Courtyard layout · REVISED 3 Nov 2026, 10 Nov 2026 (no TV, 6 seats facing the breeze) · a level floor, movable furniture, the enclosure on the kitchen wall · Taif / Palm House V8.2

Owner decisions 3 Nov 2026 (the V8.0 layout of 1 Nov 2026 revised: no step, no built-in benches, the enclosure moved east; 10 Nov 2026: NO TV, the seating re-arranged for 6 facing the outlet arch and the enclosure, the core's face straight) · clear dimensions between finished faces · the data in `3d/character.yaml` `courtyard_layout` (built in the 3D) and `studies/air_system.typ` (the grille) · every size assumed; nothing here is for construction

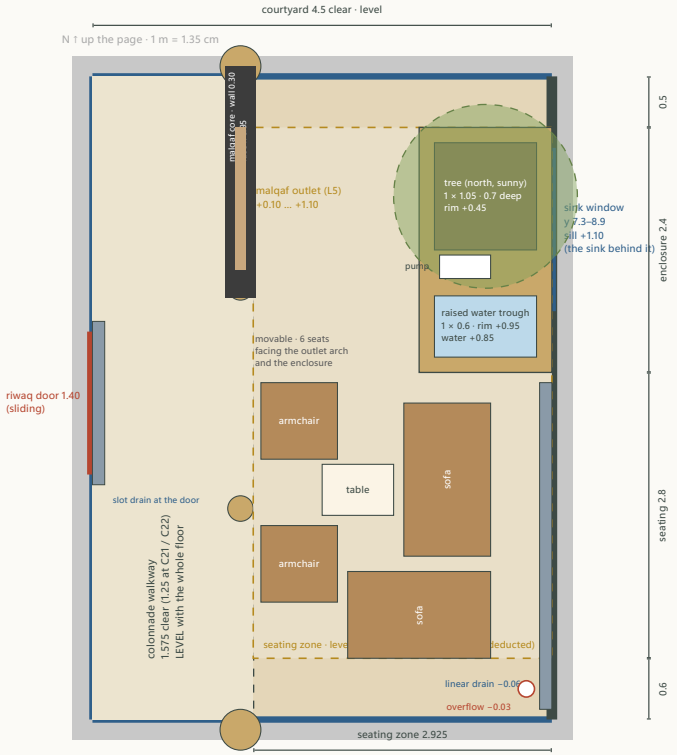
- **Courtyard:** 4.5 × 6.3 m between the finished faces (28.35 m²), **the whole floor LEVEL** (owner, 3 Nov 2026: no step anywhere; the V8.0 sunken seating is withdrawn): the colonnade walkway (1.575 m clear to the soffit edge, 1.25 at C21 / C22), the seating zone and the three cleaning strips at the glass are one surface with gentle falls (page 2). Honey-light stone, slip-resistant, no nosing, no riser light.
- **Paths kept free:** the colonnade walkway (nothing west of the soffit edge x 5.925); the riwaq door (sliding 1.40) and the living's glass (a 0.6 m strip); the women's majlis glass (a 0.5 m strip, **the north side freed**: nothing stands in front of the majlis glass any more); cleaning access along the kitchen wall between the enclosure and the chairs (0.6 m in front of the grille).

- The step, the nosing, the riser light and the three built-in benches are **removed**; the floor is level; the furniture is movable. The enclosure left the north side (the women's majlis glass is free) for the kitchen wall in front of the sink window; the TV (removed altogether on 10 Nov 2026, with its surround) had moved south; the malqaf outlet is in the west arcade since V10.0. The data: `3d/character.yaml courtyard_layout`

2 · Movable furniture for 6, facing the outlet arch and the enclosure (owner, 10 Nov 2026)

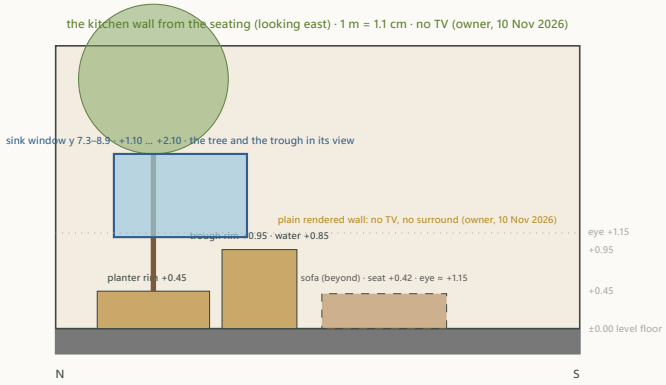
- **Modern movable pieces** (the owner chooses them), **every seat with a back, no poufs or stools**: **sofa A** (2 seats, 0.85 × 1.5) with its back to the kitchen wall (0.6 m behind it for cleaning) **facing west, the outlet arch** and the breeze; **sofa B** (2 seats, 1.4 × 0.85) with its back to the south strip **facing north, the tree and the water**; **two armchairs** at the colonnade edge facing the group and the enclosure; the low **table** 0.7 × 0.5 in the middle: **6 seats fit** with the paths clear (the colonnade walkway west of the soffit edge, 0.6 m at the living glass, 0.5 m at the majlis glass, 0.6 m at the kitchen wall, 0.3 m between sofa A and the enclosure). The breeze from the outlet (louvres aimed south-east) crosses the armchairs and sofa A first. Outdoor-rated fabrics, cushions stored in the hospitality kitchen's cupboard.

- **Seating area gained:** the level zone east of the soffit edge from the north strip to the south strip is 15.21 m²; less the enclosure (3.12 m²) **12.09 m² free**, against 10.53 m² in the sunken pit: **+1.56 m² (+15 %)**; and the colonnade strip (9.92 m²) is now at the same level, so the whole floor is one usable surface. **After L5 (V10.0):** the courtyard is an L-shape, 27.19 m² on axes; clear ≈ 24.88 m² (the rectangle 28.35 less the malqaf core's footprint 3.47 m² in its north-west corner); the seating zone's clear area 12.09 m² (2.925 × 5.2 less the enclosure).
